Inspection Report for North Sturbridge Road Solar Facility

NPDES ID No.: MAR10031G

Inspection Date: 7/13/2022

**FIGURE 1:
SWPPP
INSPECTION
SKETCH
7/13/2022**

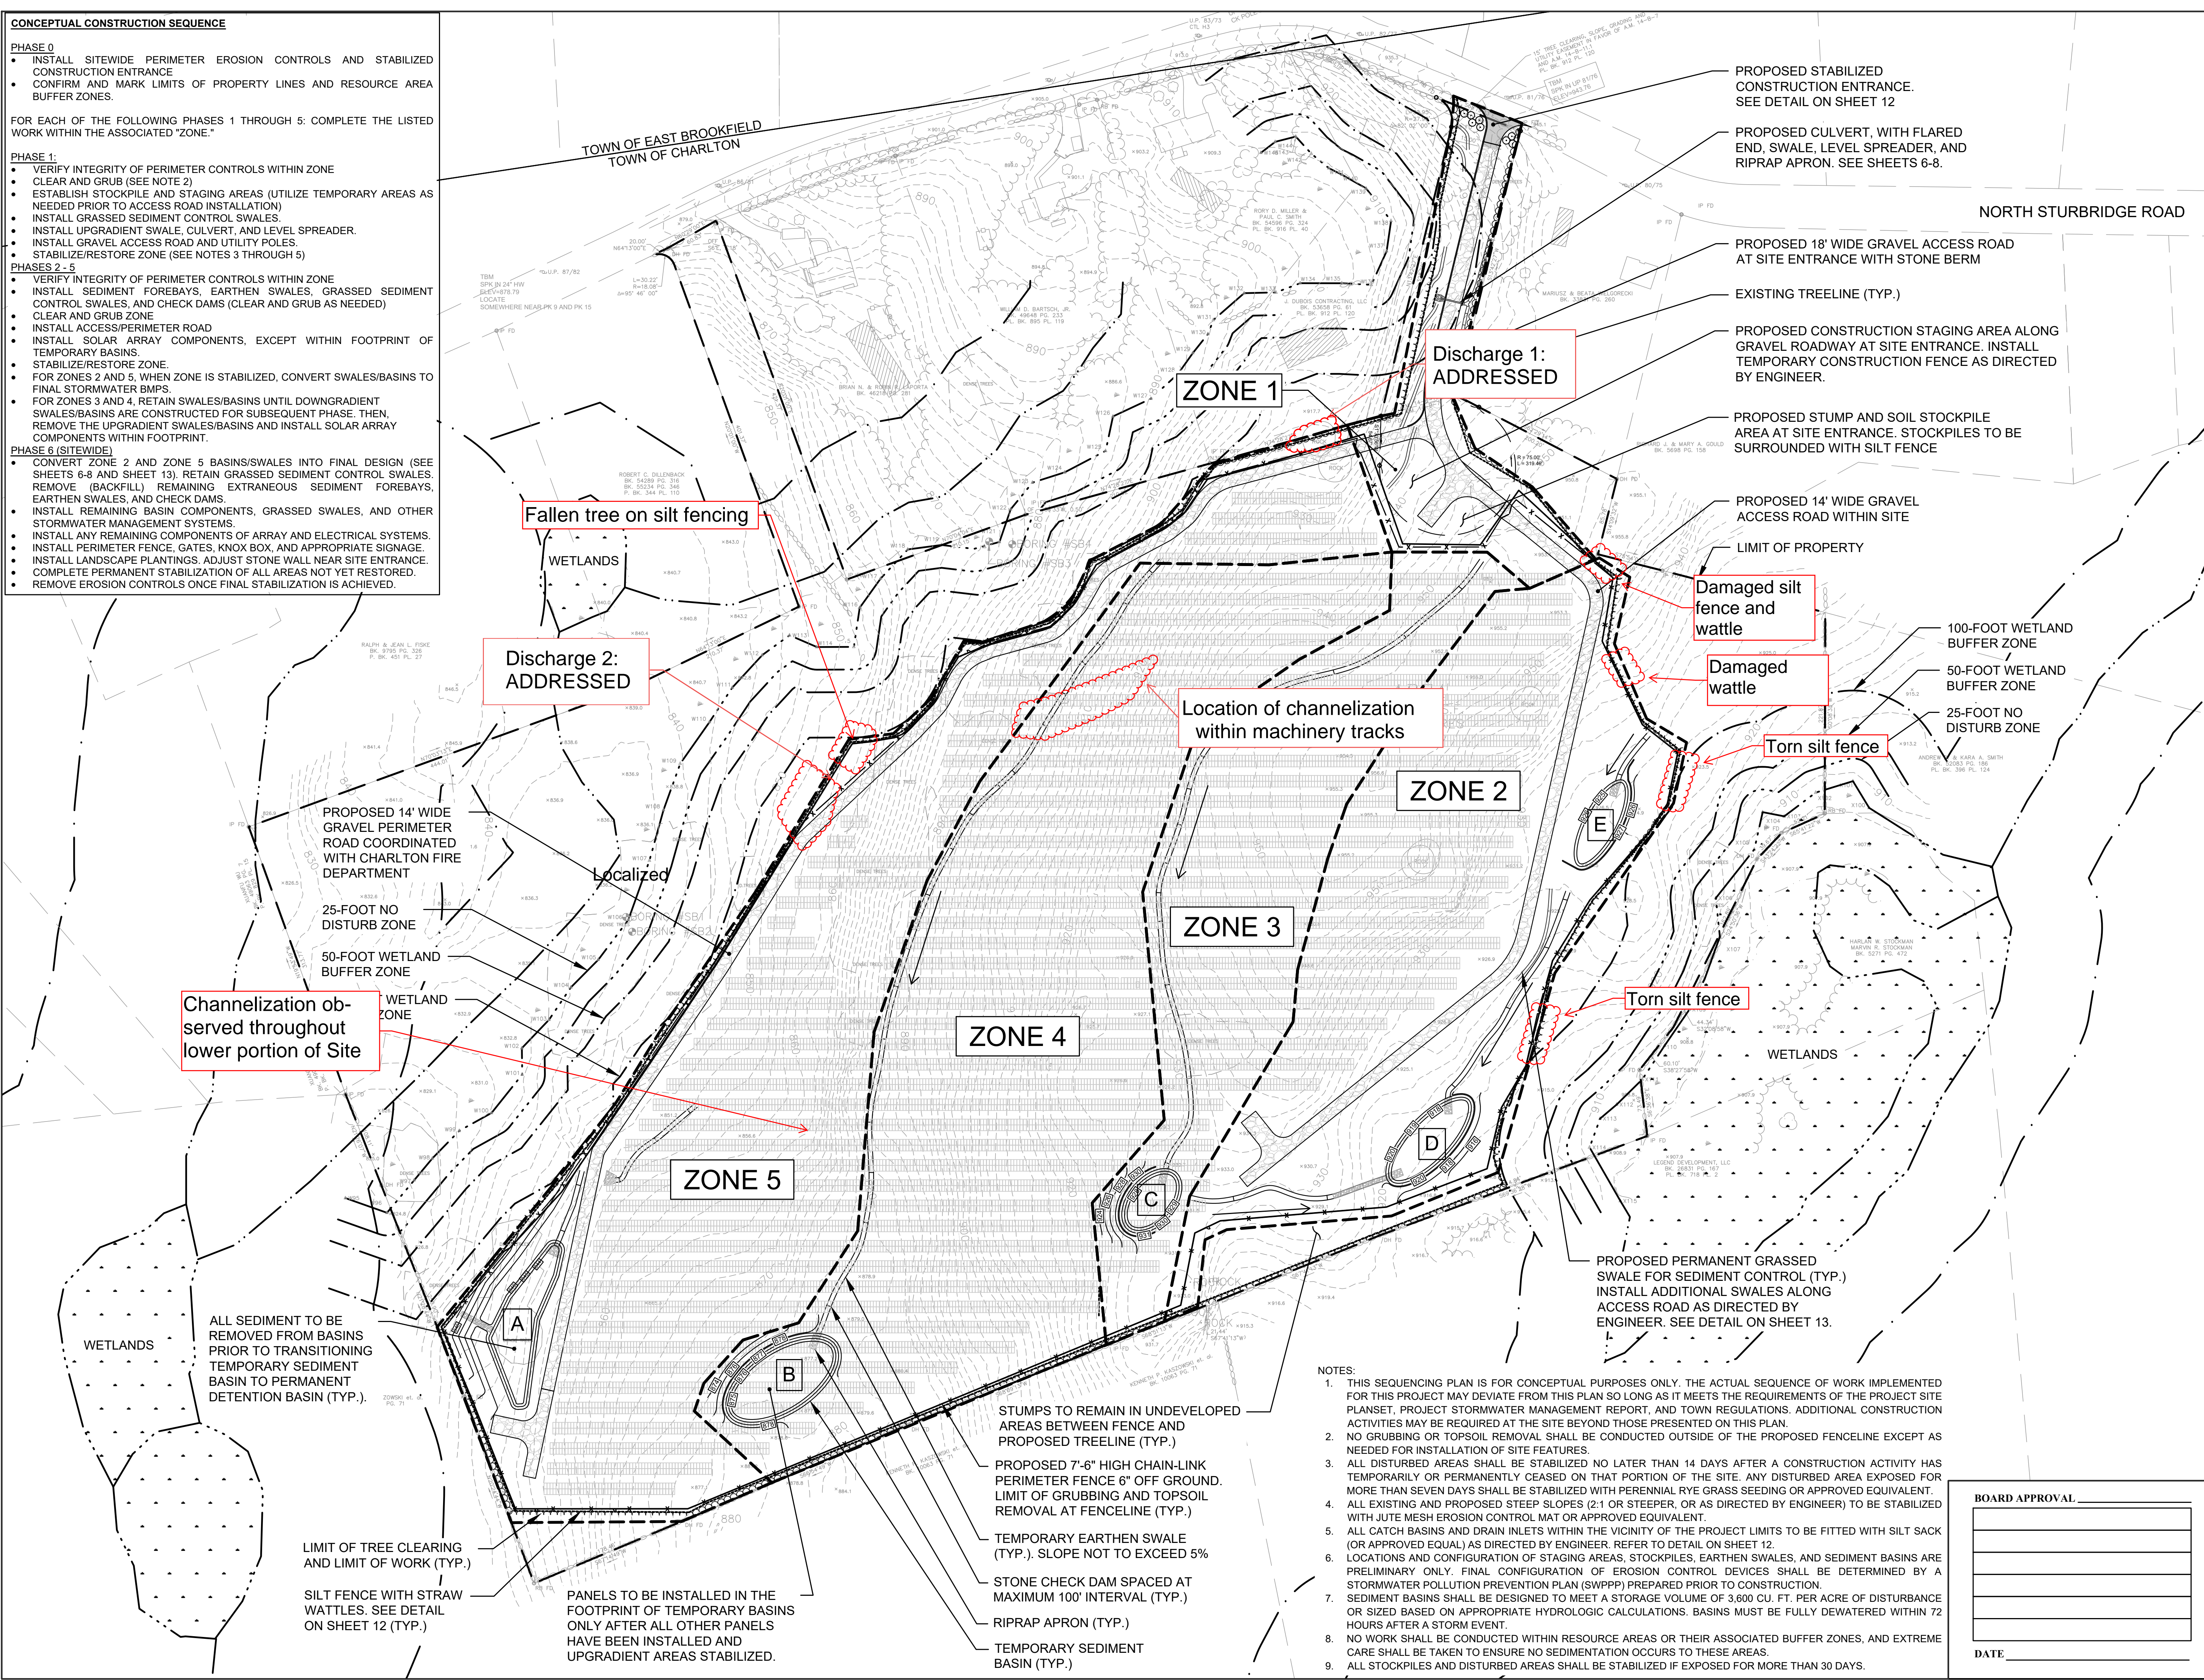
Type/Location of E&S Control	Maintenance Needed?*	Corrective Action Required?*	Date on Which Maintenance or Corrective Action First Identified?	Notes
1. Silt Fence and Straw Wattles	Yes	No	3/15/2022	On 7/13/2022 BETA observed fallen tree damage to the silt fence on the western perimeter of the Site, damage was first observed on 6/20/2022 On 7/13/2022 BETA observed damage to the wattles in the north-east and eastern corners of the Site, damage was first observed on 3/15/2022. BETA also observed the silt fence to be partly torn in the southeastern corner of the Site, damage was first observed on 3/27/2022. General maintenance is needed for the entire silt fence. No evidence of discharge was observed.

2. Informal access road along northern portion of the Site	Straw mulch or hydroseed	<input type="checkbox"/> Yes <input checked="" type="checkbox"/> No	Erosion channels are beginning to form within upgradient portions of the informal access road (Figure 1). The contractor indicated that stabilization by smoothing out soils and seeding or spreading mulch would occur on 7/30/2021. Stabilization of this area has not been initiated. After inspection of the area on 8/24/2021, it was determined that

Damaged silt fence and wattle

Damaged wattle

Torn silt fence

Torn silt fence
